WHYTES GULLY NEW LANDFILL CELL

Response to Submissions/Preferred Project Report

Submitted to:
NSW Department of Planning and Infrastructure

Report Number. 117625003

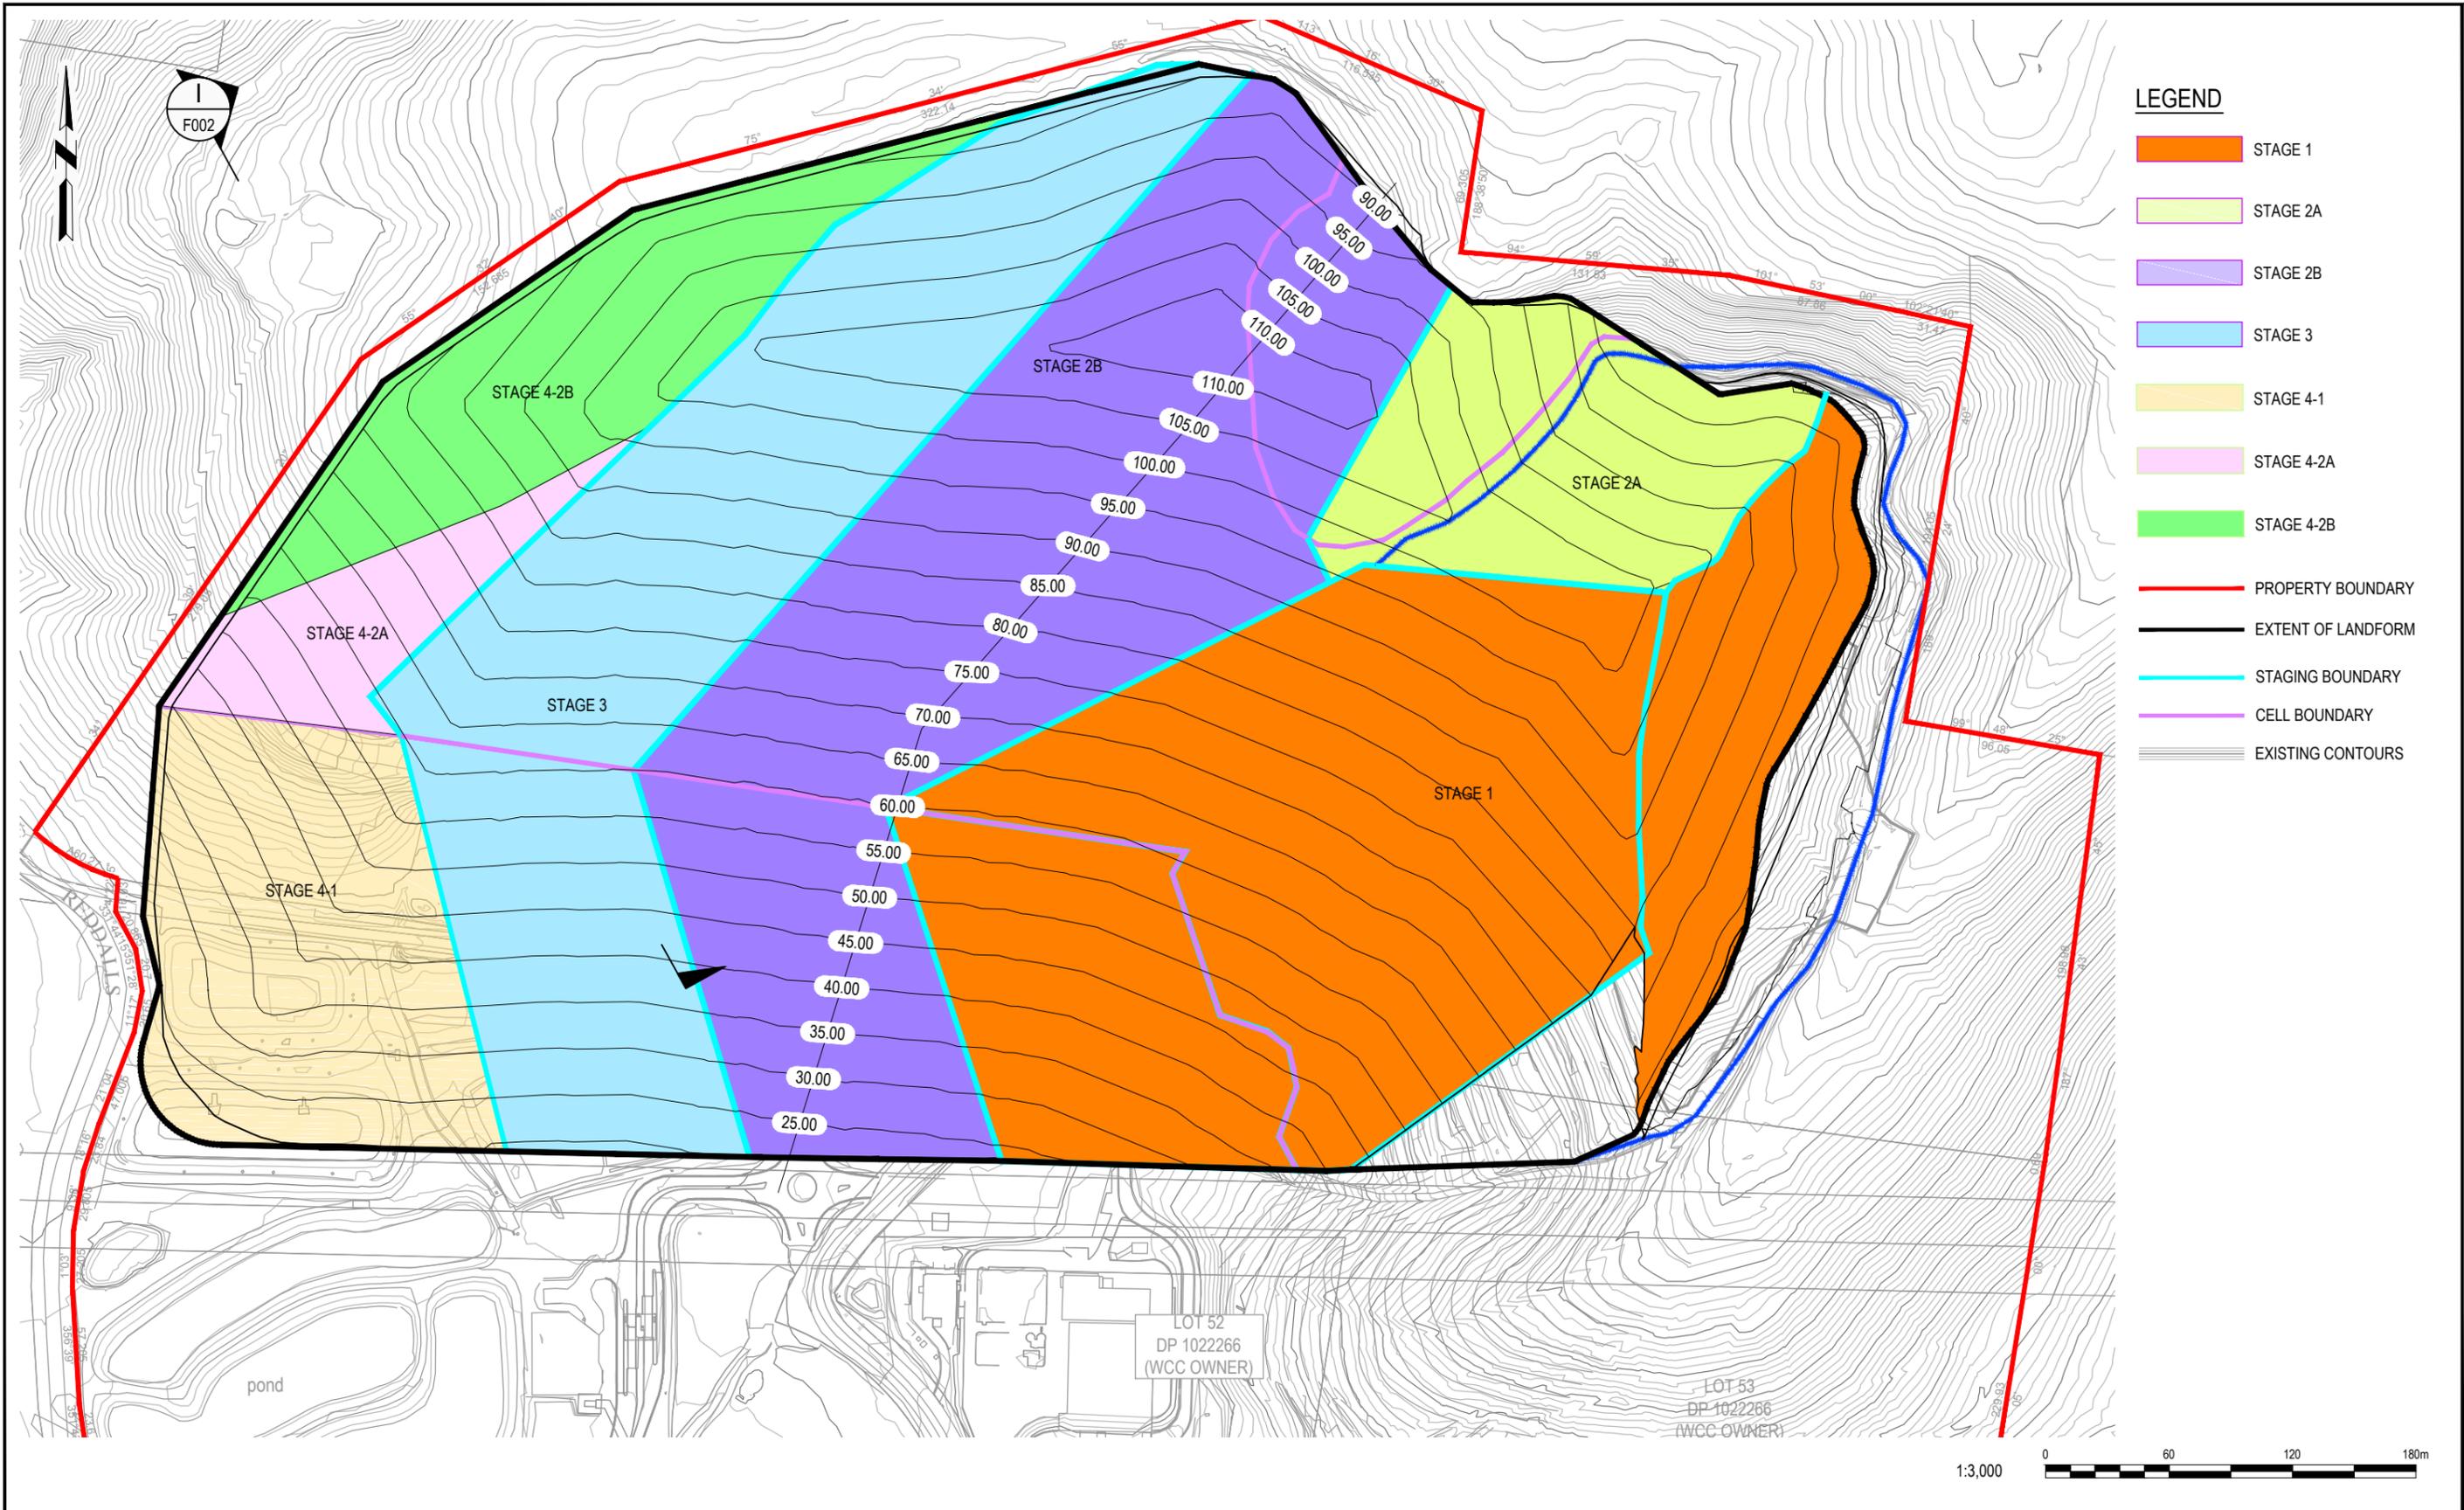
- 1) *The Department needs to be satisfied that the project would achieve an acceptable acoustic environment for local residents.*
- 2) *As discussed at our on-site meeting on 21/9/2012, the Department suggests that you consult with the EPA and consider reducing the footprint of landfilled waste in Stage 4 to increase the buffer distance between N1 and reduce noise levels to comply with the INP amenity criteria. In this regard, a preferred project report which addresses this issue should be submitted to the Department as part of your response to submissions report.*

- 3) *The cumulative (ie construction and operation) predicted noise levels at receivers N1 and N2 are significantly greater than the Project Specific Noise Level (PSNL) – up to 54 dBA at N1 and 45 dBA at N2. The proponent has not provided any description of feasible and reasonable mitigation measures to reduce the predicted levels. The EPA advises that it does not normally Licence to levels significantly greater than the PSNLs.-*
- 4) *The EPA has not included receivers N1 and N2 in the noise limits table in the attached recommended licence conditions, on the assumption that Planning will advise the proponent that the negotiated agreements process in Chapter 8 of the INP is available to them, and that Planning will require the proponent to provide evidence of negotiated agreements being in place with N1 and N2 before any Project Approval can be issued.*

- 2) *The EPA has recommended noise limits for receivers N3 to N5 based on the predicted cumulative noise levels in Tables 15 and 16 in the NIA. Where the levels are more than 2dBA above the PSNLs, the EPA recommends that the proponent implement a noise management plan (NMP) to minimize noise from the site over the life of the landfill. The EPA does not and will not approve or endorse a NMP and does not need to review such a plan.*

In response to comments 1, 2 and 3, to further reduce the potential cumulative effects of the construction and operational activities at Receiver N1, the final Stage (4-2) of the Project has been broken into two parts (Stage 4-2A and Stage 4-2B) (refer Figure 1). Stage 4-2B would be the final stage of the Project to be constructed. The division of the stages as shown in Figure 1 is such that all activity up to and including Stage 4-2A occurs behind the existing north-east ridgeline, and at a greater distance from Receiver N1 than for Stage 4-2B (refer Figures 2). It is proposed that approval of Stage 4-2B would be conditional on further noise modelling and assessment of mitigation measures to be conducted prior to construction. This has been reflected in the revised draft Statement of Commitments in Section 5.0 of the Report. Further details of the revised staging including proposed volumes and timelines are provided in Section 4.0 of the Report.

The breaking of Stage 4-2 into two parts allows a greater level of detail in modelling the level and duration of noise exposure to Receiver N1. The reduced duration of exposure is discussed in Section 4.0, and shows that for construction and operation activity nearest to Receiver N1 (in Stage 4-2B) is approximately six years, which is less than the nine years presented in the EA for the whole of Stage 4-2.

The proposed splitting of Stage 4-2 of the Project into Stage 4-2A and 4-2B has reduced the construction and operation noise levels at Receiver N1 to below their respective calculated noise limits (refer modelling results in Table 3 to Table 5). In addition mitigation measures have been incorporated to reduce the noise generated by the Project upon the site and surrounding area. This includes the fitting of all plant and equipment with appropriate silencers and broadband reversing alarms.

In order to address comments received from DPI principally relating to potential offsite noise impacts (refer Section 3.4 of the Report), the final Stage of the EA (4-2) is proposed to be split into two parts (Stage 4-2A and Stage 4-2B) (Refer Figure 1).

Figure 5: Recommended Buffer Distances along Riparian Corridors

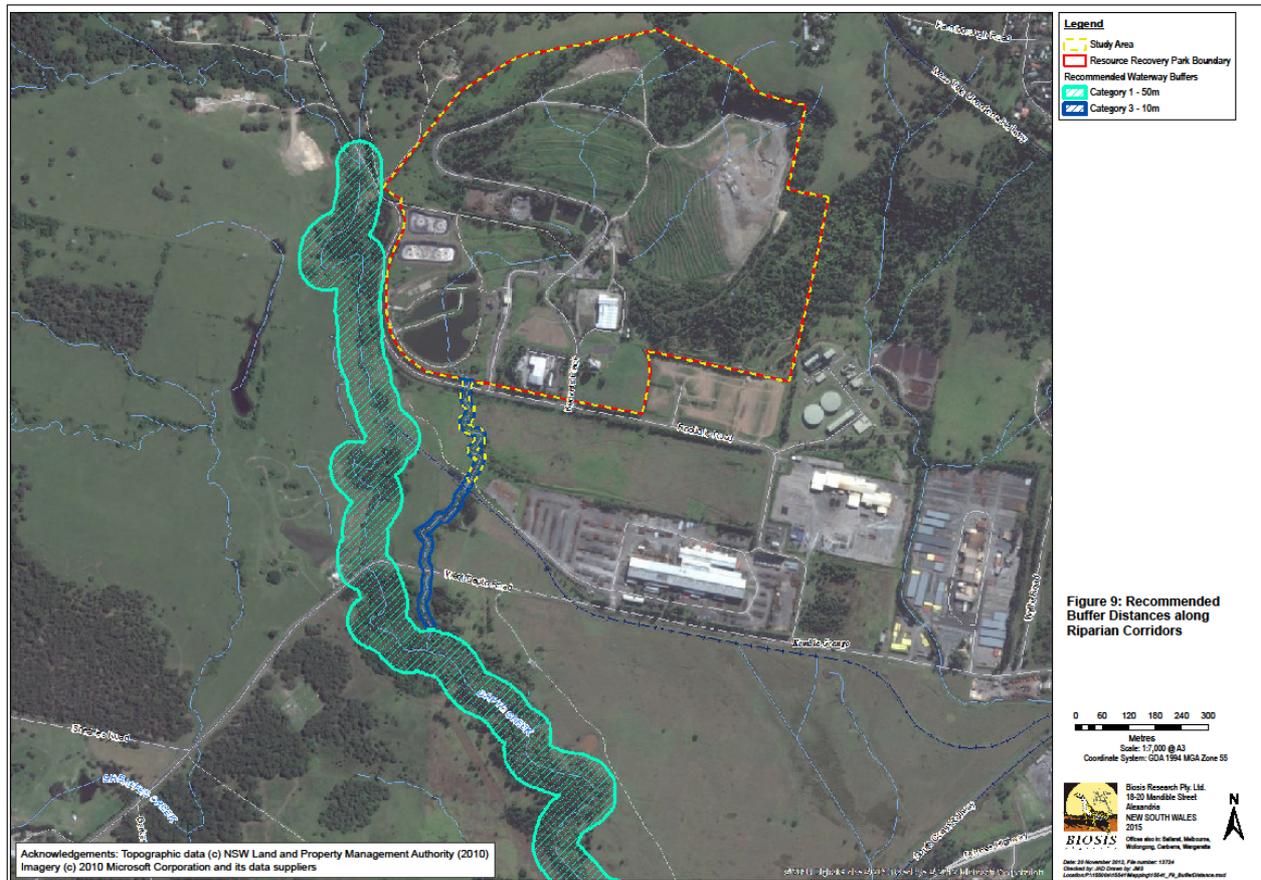
- 1) *Section 3.5.4 of the Terrestrial and Aquatic Flora and Fauna Assessment (TAFFA) in Appendix F refers to the RCMS riparian buffer widths to be considered in the planning and design of the proposal. The EA (Section 13.3) and Section 4.2 of the TAFFA recommends as a mitigation measure to maintain suitable buffer distances from nearby waterways based on the stream orders of waterways and the subsequent categories identified within the Wollongong DCP (2009). It should be noted the riparian land management section in Wollongong DCP 2009 (Chapter E23) is not based on stream order but on the DIPNR (2004) Riparian Corridor Management Study. Map 7 in DIPNR (2004) is the relevant riparian map for the Whytes Gully site. It is not clear how the recommended buffer distances shown on Figure 9 in Appendix F have been derived.*

- 2) *The 12th dot point under Flora and Fauna (page 256, Volume 1) refers to maintaining suitable buffer distances from nearby waterways and it notes these buffer distances are based on stream orders of waterways and the subsequent categories identified within the Wollongong City Council Development Control Plan 2009. The riparian land management section in Wollongong DCP 2009 (Chapter E23) is not based on stream order but on the DIPNR (2004) Riparian Corridor Management Study (RCMS).*

Generic advice sought from NOW and WCC as a part of this response to submissions indicates that the new *Guidelines for riparian corridors on waterfront land* (NSW Office of Water, July 2012) have replaced the RCMS method and would be the minimum that is required from NOW and WCC when assessing riparian buffer widths.

Figure 9 of the Biosis report has been amended to further define the buffer widths of the merit based assessment, as well as the usage of Map 7 of the DIPNR (2004) Riparian Corridor Management Study (refer Figure 5 below). All proposed buffer zones are outside of the Resource Recovery Park boundary.

Figure 6: Time series of measured and modelled 24-hour average PM₁₀ concentrations at R1 (Stage 4).

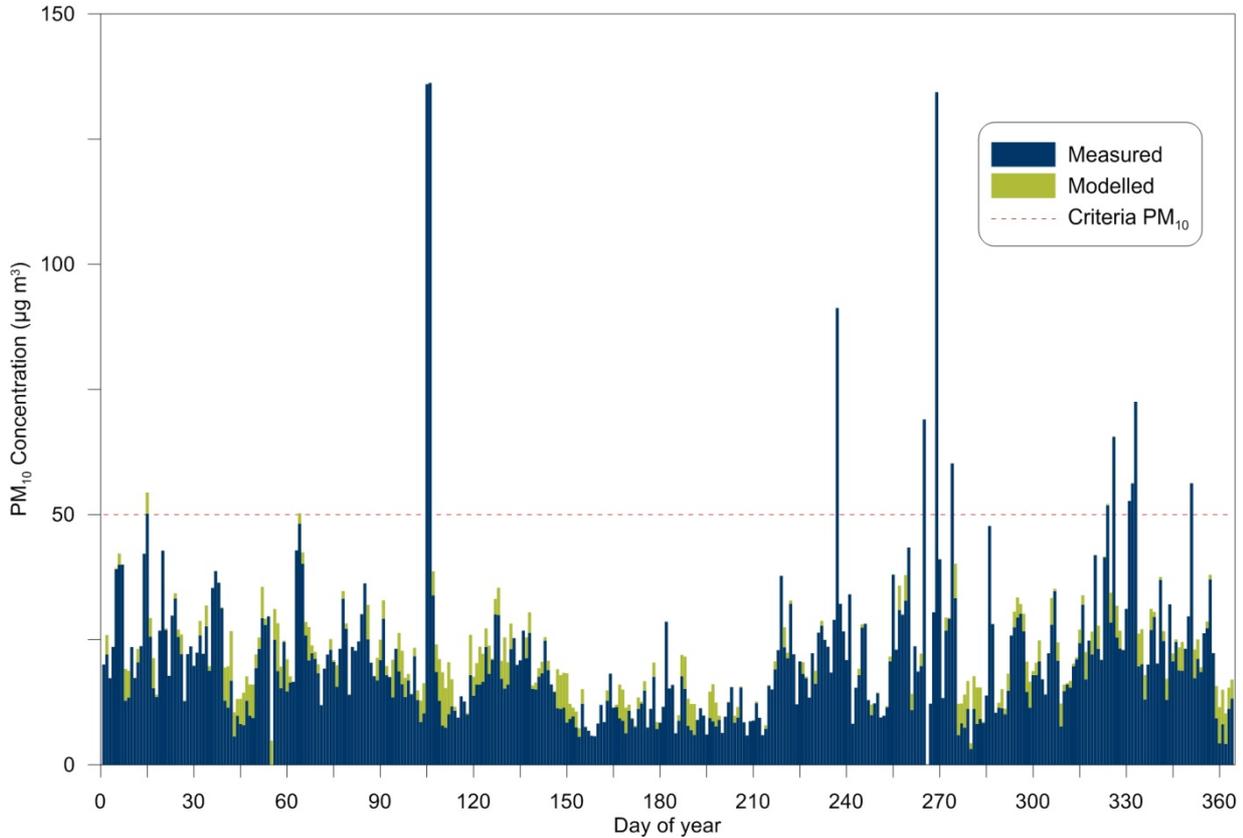
- 1) *The issue of PM10 24-hour average exceedances requires some clarification. The proponent should confirm the cumulative 24-hour average PM10 assessment results. If the results shown in Figure 7.12 are correct, the proponent should provide a revised assessment including additional controls to ensure no exceedances are predicted to occur due to project operations. If the assessment does not predict exceedances of impact assessment criteria for PM10, the EPA recommends conditions of approval.*

The NSW EPA was correct that the text and Figure 7.12 were conflicting. Figure 7.12 was correct and did show one additional cumulative exceedance of the 24-hour average PM10 criterion at R1 during Stage 4. It is noted however, that this was a conservative assessment and the exceedance was less than $2 \mu\text{g}/\text{m}^3$ above the criterion, on a single occasion.

Figure 6 shows the updated time series (measured and modelled incremental increase) for the nearest residence (R1) during Stage 4, assuming that dozer travel routes are kept moist. This results in no predicted additional exceedances above the 24-hour PM10 criterion.
